# UNITED STATES PATENT AND TRADEMARK OFFICE

10/552,257

<b>Office Action Summary</b>	<b>Application No.</b> 10/552,257	<b>Applicant(s)</b> YAMAMOTO ET AL.	
	<b>Examiner</b> Zachary Snyder	<b>Art Unit</b> 2889

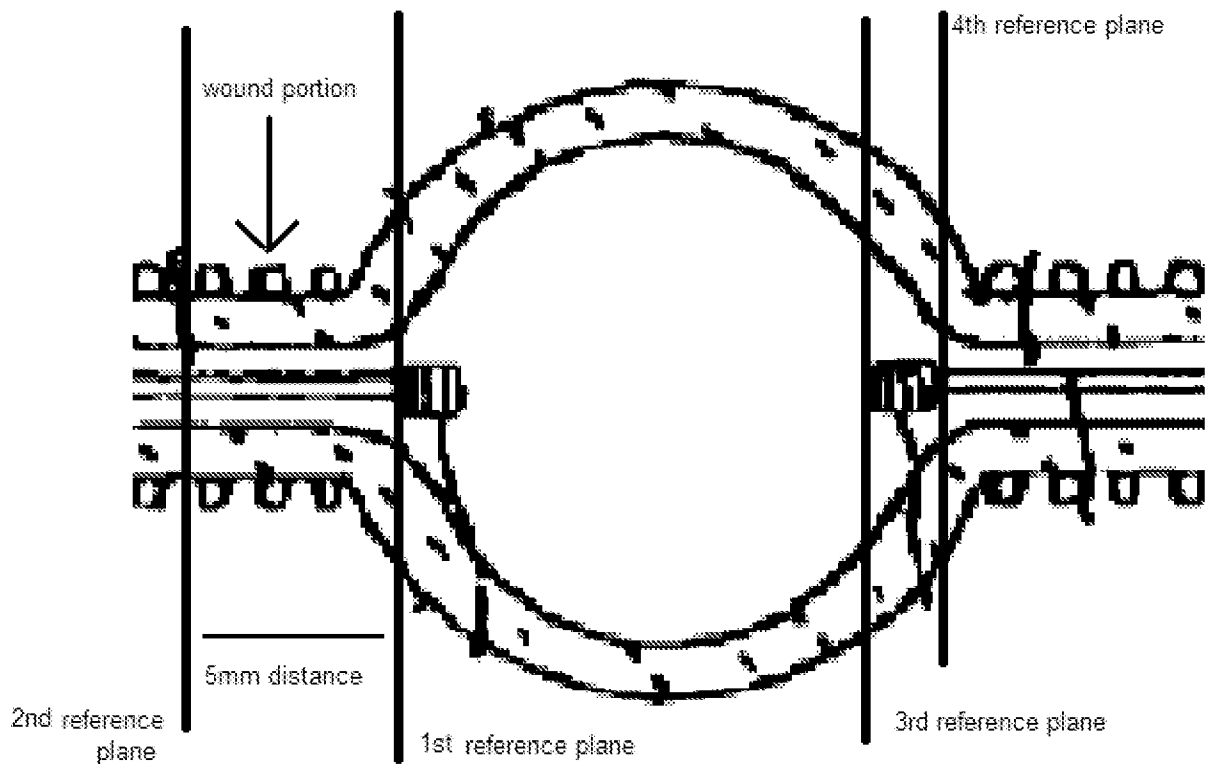
a remaining section of the lead wire forming a lead portion that extends from the wound portion across the light emitting part in proximity to or contacting with an outer surface of the light emitting part (junction conductor CC1, paragraph 170, is formed in proximity to the outer surface of the light emitting part), to a side of the discharge lamp on which the second sealing part is disposed (shown in figure 4), wherein

the lead portion is electrically connected to the electrode (junction conductor CC1 is connects the electrode pair and outer lead terminals, paragraph 55), of the pair, positioned nearer the second sealing part (shown in figure 4), and at least a section of the wound portion is wound substantially spirally at least 0.5 turns in a range from a 2<sup>nd</sup> reference plane to a 3<sup>rd</sup> reference plane (shown in figure below), and

a closed loop around one of the light emitting part and the first sealing part does not exist within the range (shown in figure below and figure 4 to see the loop is open), where

the 2<sup>nd</sup> to 3<sup>rd</sup> reference planes are parallel to a 1<sup>st</sup> reference plane lying orthogonal to a bulb longitudinal direction and including an end of the discharge space positioned at a base portion of the electrode nearer the first sealing part (shown in figure below),

the 2<sup>nd</sup> reference plane being distant 5 mm from the 1<sup>st</sup> reference plane (the length of the sealing part is 8mm, paragraph 181, so these reference planes can be chosen to be 5 mm apart) along the first sealing part and the 3<sup>rd</sup> reference plane passing through a tip of the electrode nearer the second sealing part (shown below).

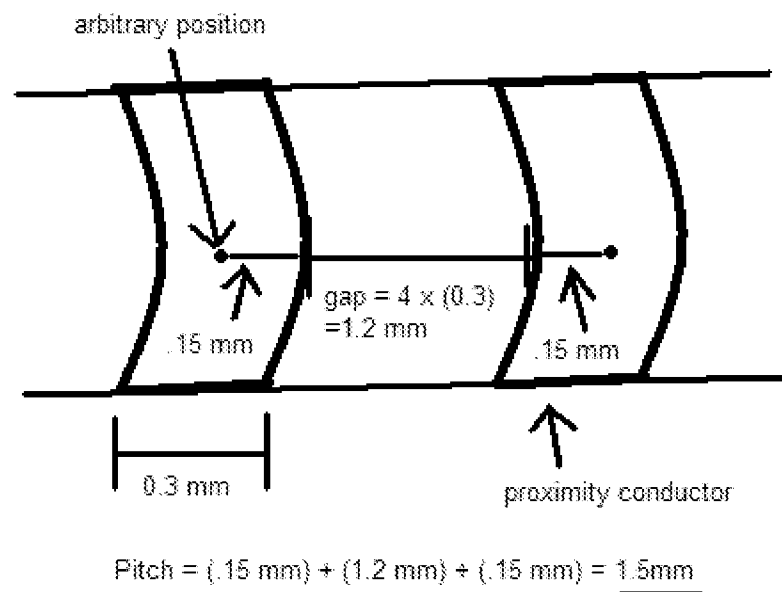
In regard to claim 4, Honda discloses the limitations of claim 1 and that in a range defined by the 2<sup>nd</sup> and 3<sup>rd</sup> reference planes, a pitch interval of the substantially spirally wound portion of the proximity conductor is at least 1.5 mm.

Honda discloses that when the winding pitch of the coil is 500%, a gap four times wider than the diameter of the metallic wire shaping the coils is defined between two adjacent turns (paragraph 92). The diameter of the coil is 0.3 mm (paragraph 186). The figure below shows that the interval pitch as defined by the applicant ("distance in the longitudinal direction from an arbitrary position on the proximity conductor to a position removed one revolution (360 degrees or 1 turn) from the arbitrary position") is at least 1.5 mm.
